Nomination Form
Anadromous Waters Catalog

Stream 111-40-10070 – Upper Extent Switzer Creek Route Correction

Stream: 111-40-10070 Route Correction

Figure 1. Map of Switzer Creek and associated tributaries.

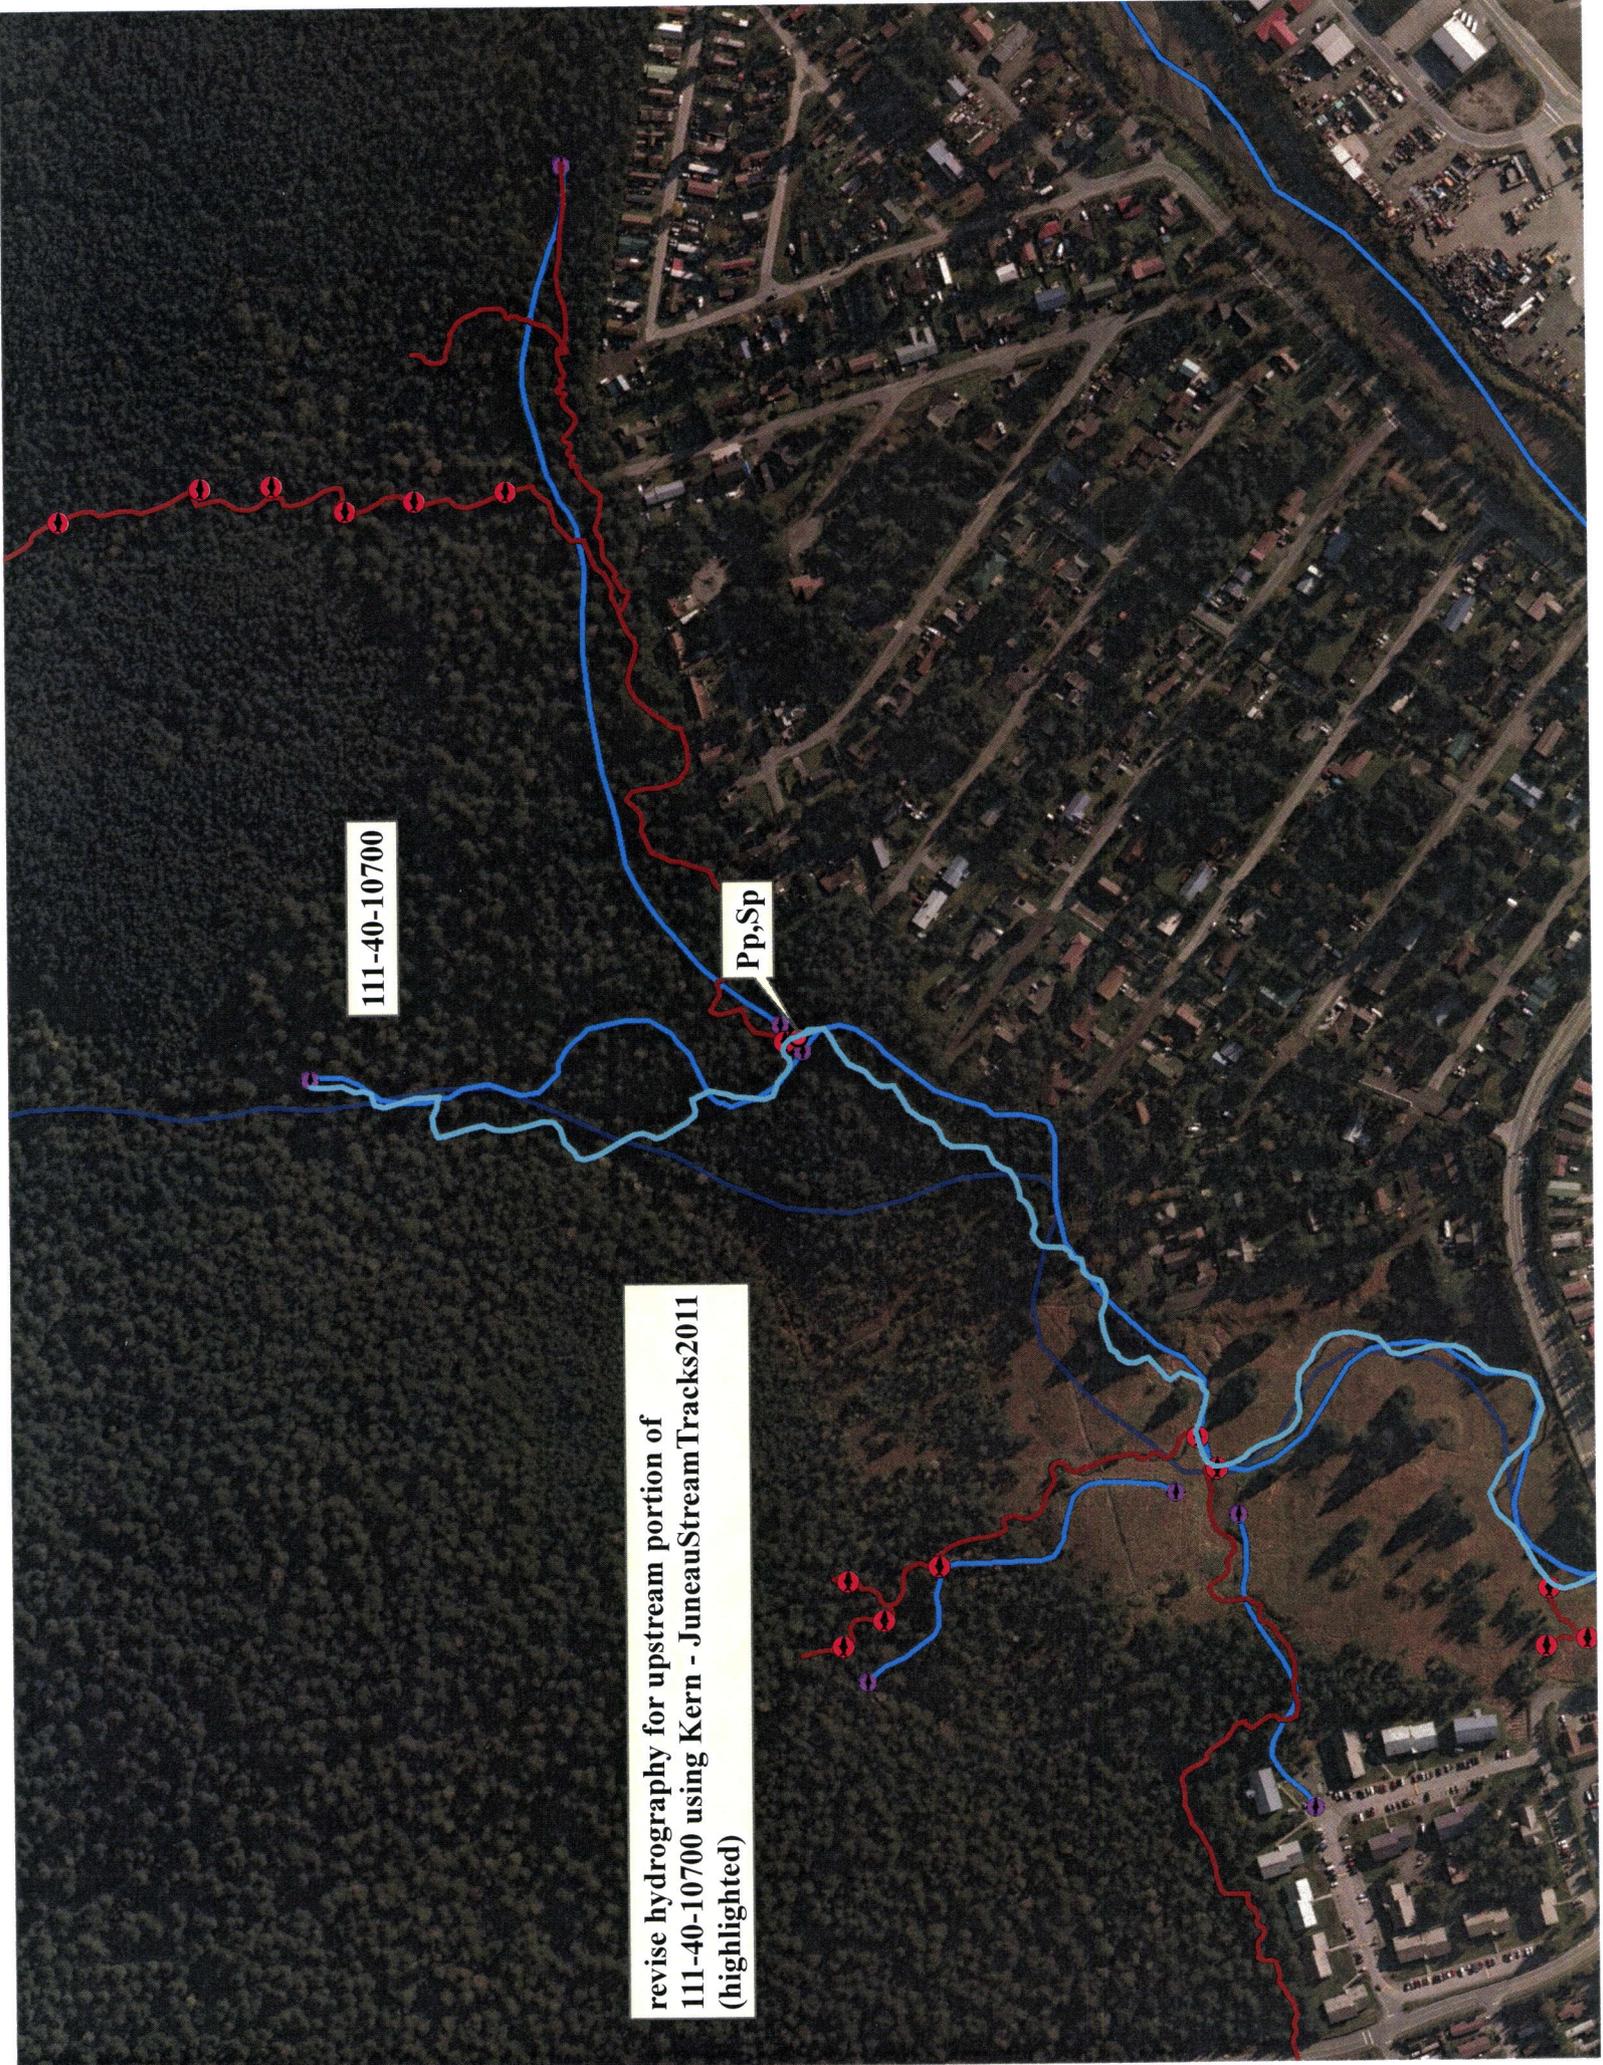
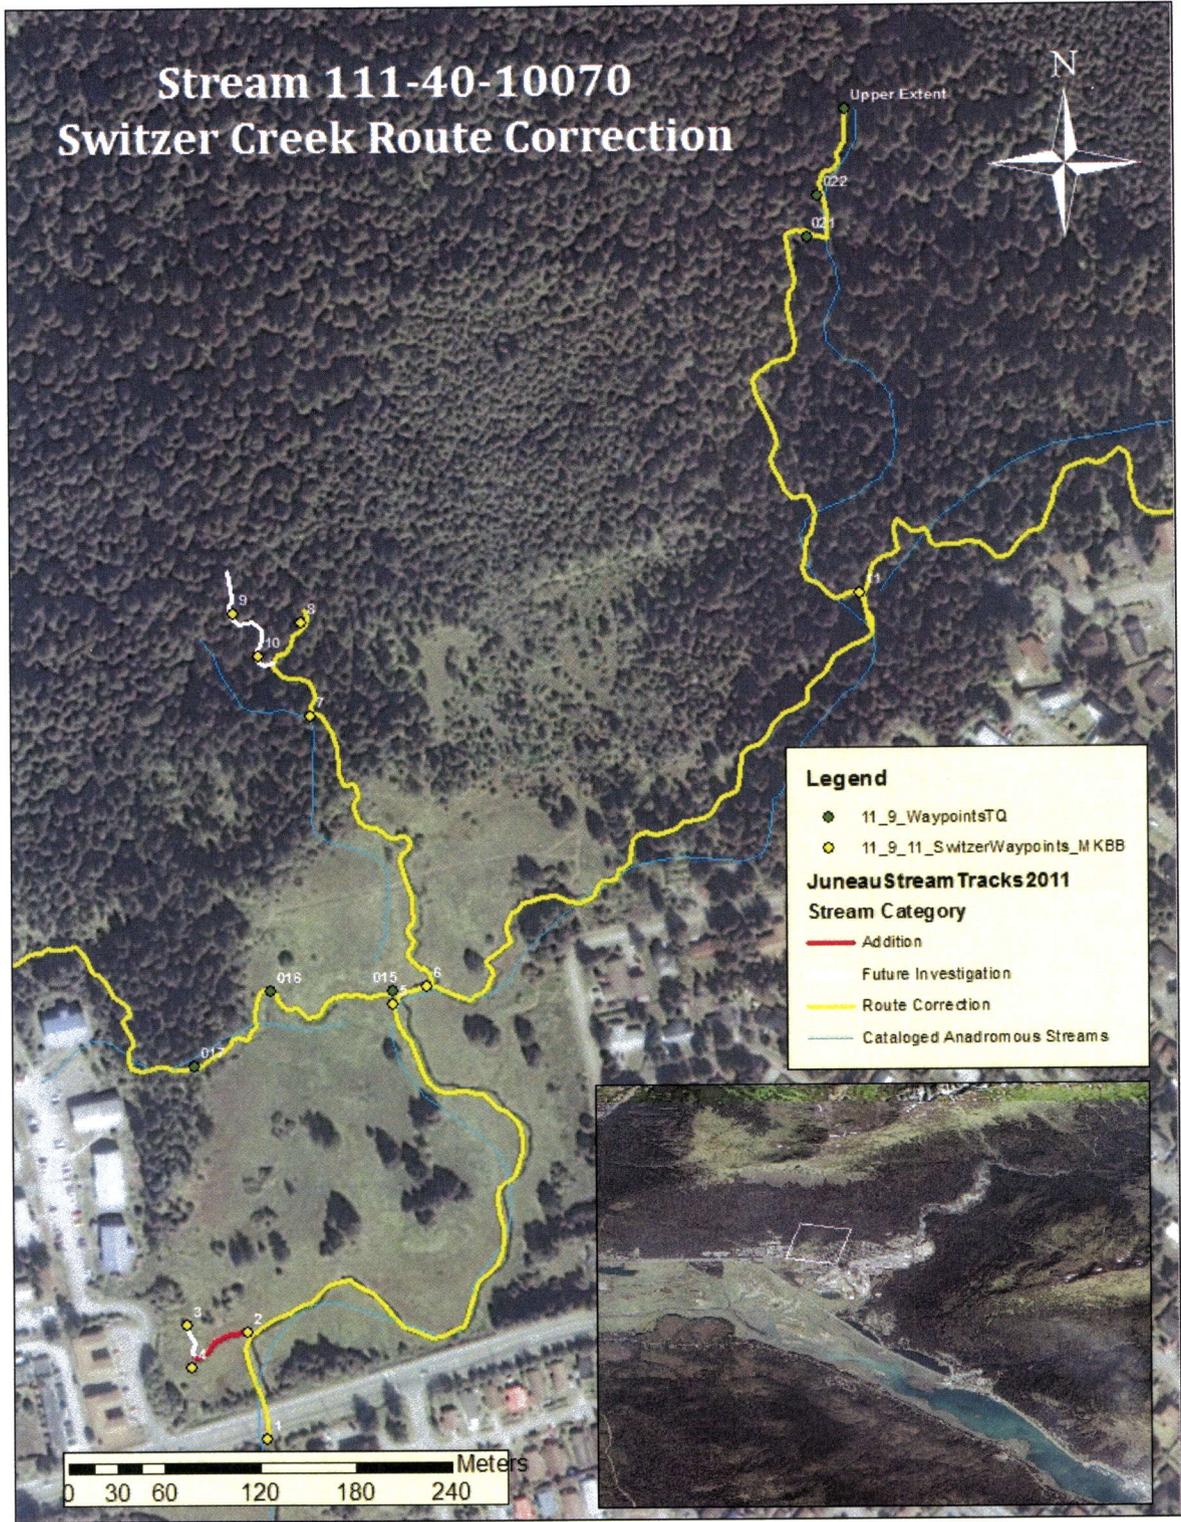
revise hydrography for upstream portion of
111-40-10700 using Kern - JuneauStreamTracks2011
(highlighted)
